PRECISION **INTERNATIONAL**

TRANSMISSIONKITS.COM

***An Automotive Leader
in Automatic
Transmission Repair***

2-Input Shaft -Large (5 pcs.)

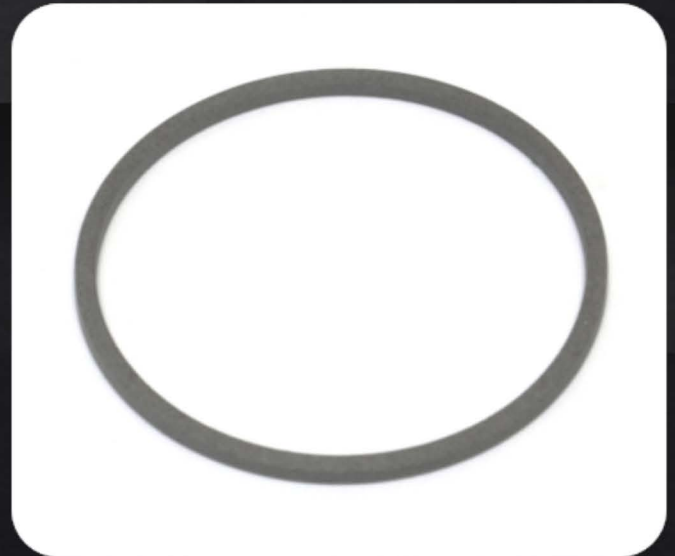
While the most significant change is the decrease in outer diameters, the slight change in the radial wall has an effect as well.

10R80 INPUT SHAFT, DIRECT/OD SEALING RING DESIGN CHANGES:

Was PI# 33614 Ford#HL3Z-7G091E 1.645" OD X .083"TH X .085" RW

Now PI# 37614 Ford# HL3Z-7G091-G 1.630" OD X .082"TH X .083" RW
